# WASTEWATER SYSTEM IMPROVEMENTS
# FOR THE
# GRAND STRAND WATER AND SEWER AUTHORITY

PART 1 TRANSMISSION PIPELINES

PROJECT NO. CA68505.71

ADDENDUM # 2 - Supplement for Rebid

SHEET NO. 15

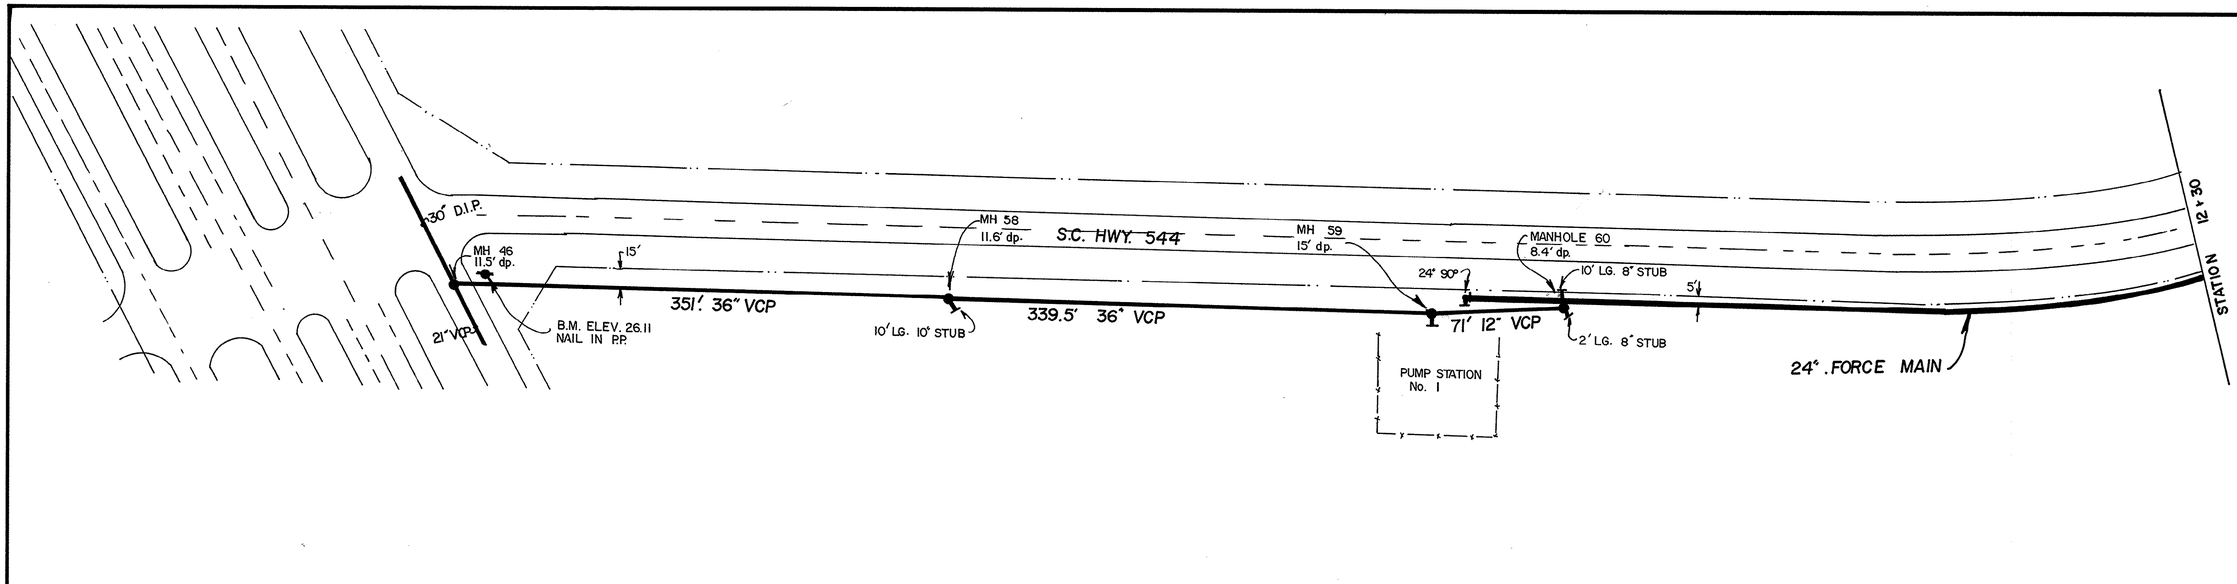
REQUEST FOR CHANGE (RFC) 5-A-I, 6-A-I & 14-C

1. ELIMINATED 21" DROP PIPING AT MANHOLE NO. 46.
2. RELOCATED 36" STEEL CASING & 20" D.I.P WITHIN FROM MANHOLE NOS. 40 TO 40A TO MANHOLE NOS. 57 TO 57A.
3. RELOCATED ALL WORK ASSOCIATED WITH TIE-IN TO EXIST. 6" FM AT MANHOLE NO. 55A TO MANHOLE NO. 57A.
4. CONNECTED NEW 10" FM (PART OF RFC 14-C, SHTS. A-2, 15 & U-2 OF THE PART I PLANS) TO MANHOLE 57A.
5. INCREASED SLOPE OF 21" V.C.P GRAVITY SEWER.

ADD 2 NOTE: RAISED 21" GRAVITY SEWER. (JAN. '79)

SHEET NO. 47

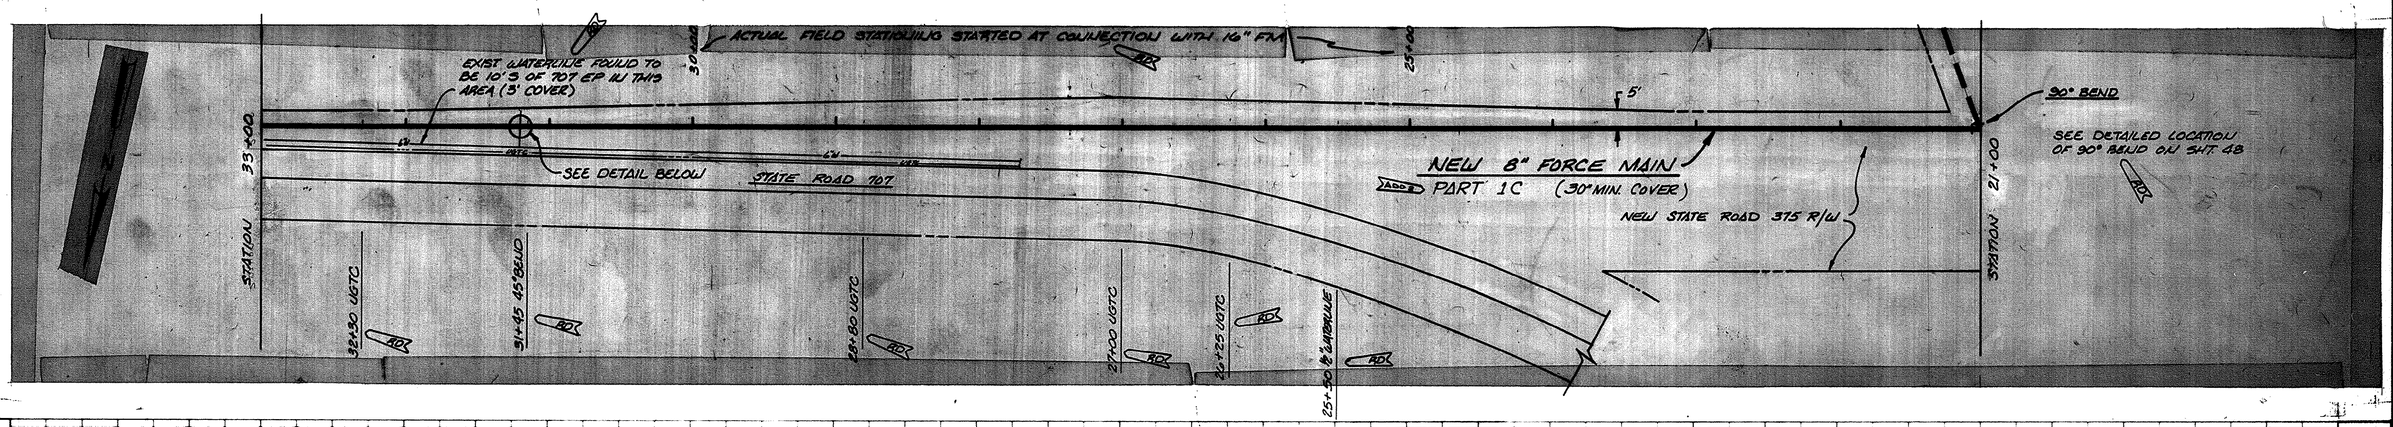
NOTE: CONTRACTOR FOR PART 2D TO TIE TO END OF NEW 8" F.M. INSTALLED BY CONTRACTOR FOR PART 1C. CONNECTIONS AND REROUTING TO BE MADE BY PART 2D CONTRACTOR AFTER W.W.T.P. IS READY FOR OPERATION.

| NO. | DESCRIPTION | DATE |
|---|---|---|
| | CHG'D 8" F.M. TO PART 1C-ADDED NOTE | |

SHEET NO. S-1

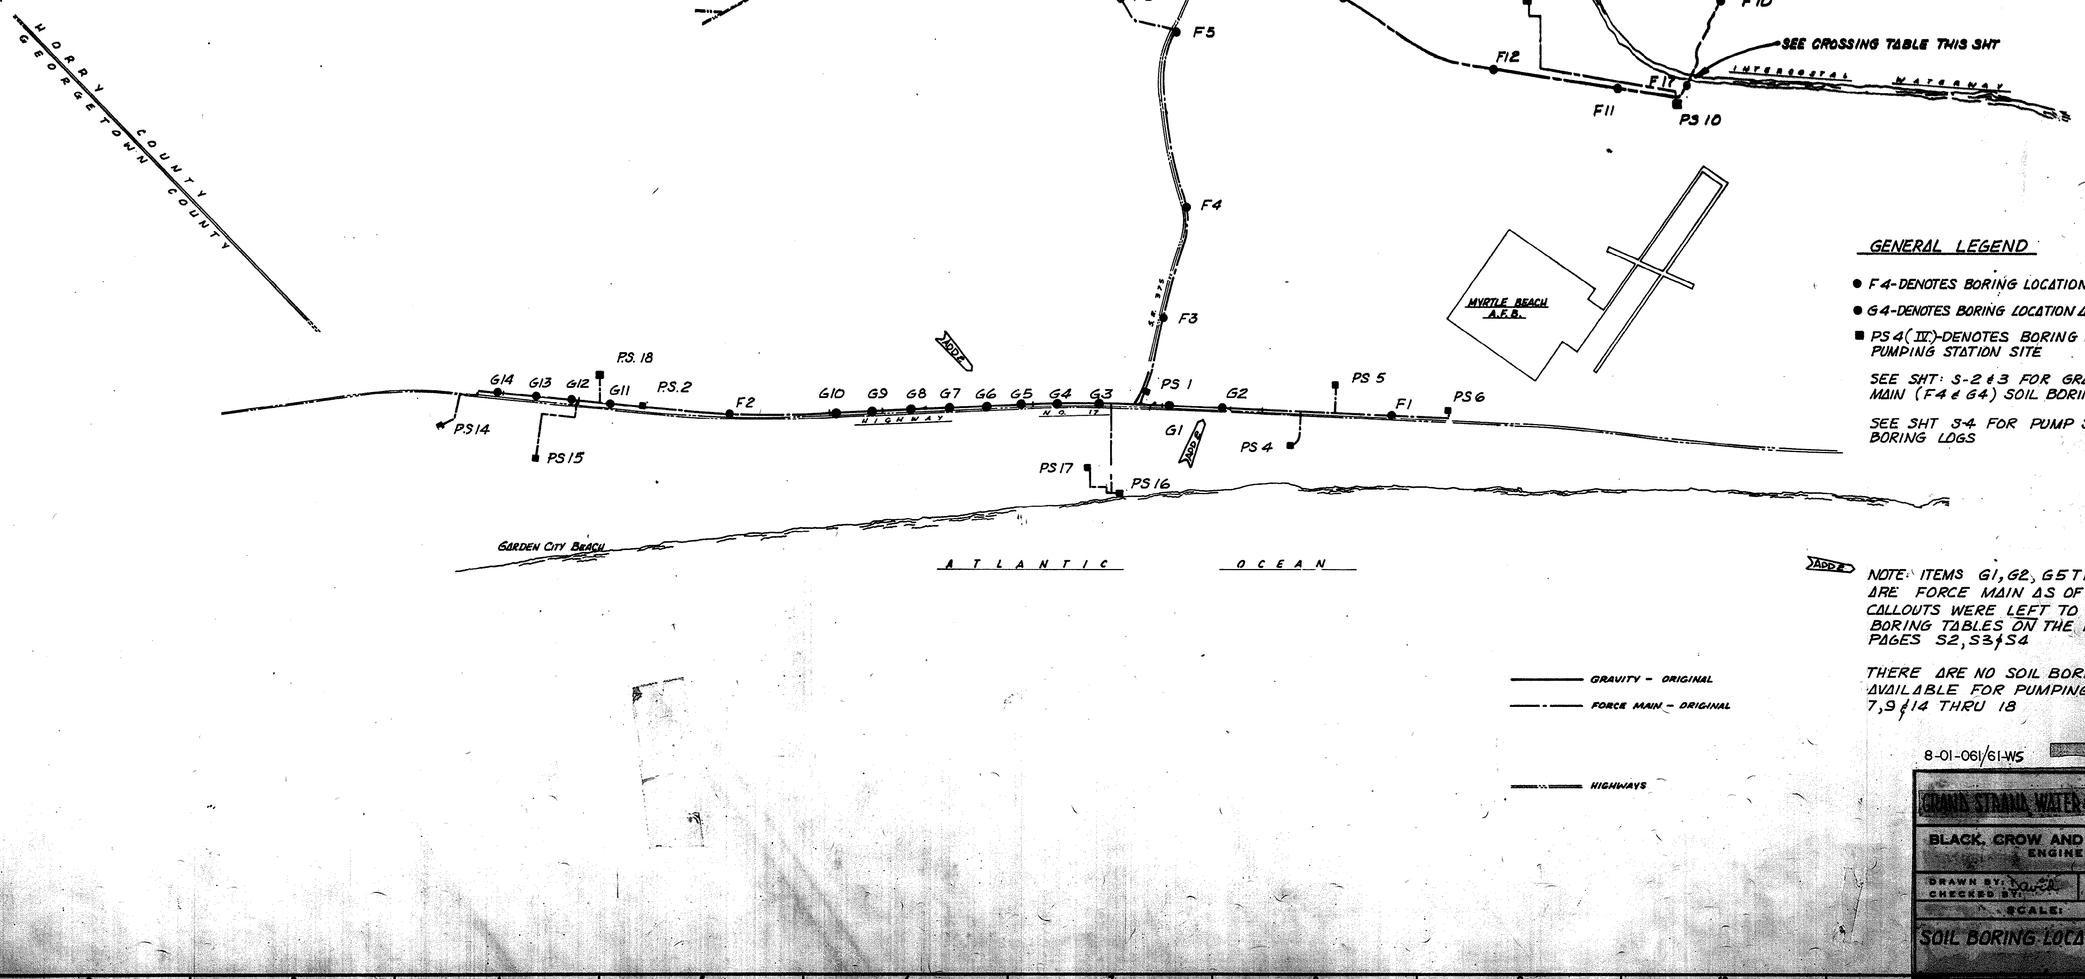
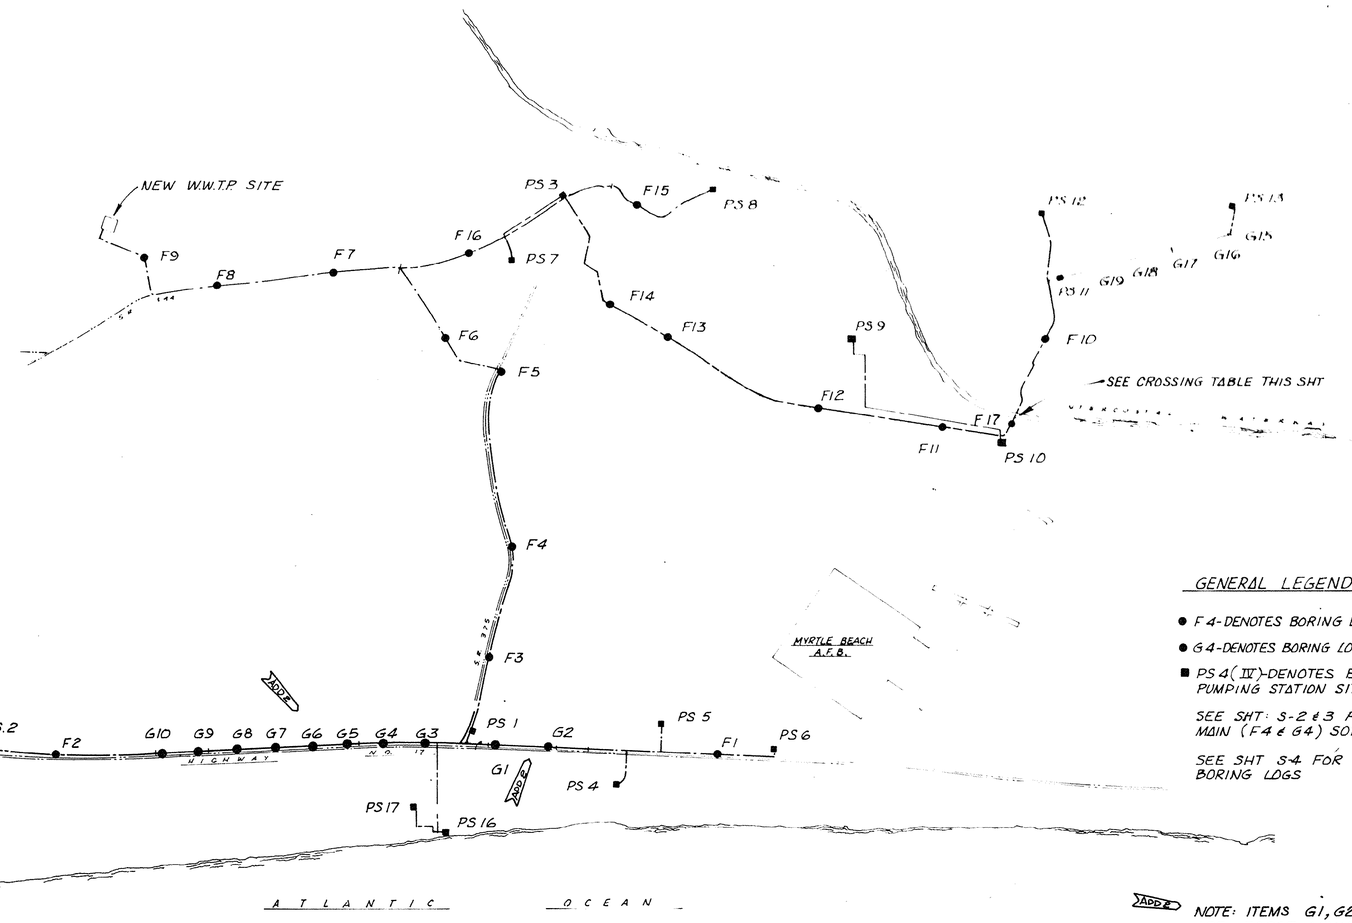
ADD 2 NOTE: ITEMS G1, G2, G5 THRU G10 ARE FORCE MAIN AS OF JAN 79. CALLOUTS WERE LEFT TO AGREE WITH BORING TABLES ON THE FOLLOWING PAGES S2, S3 & S4
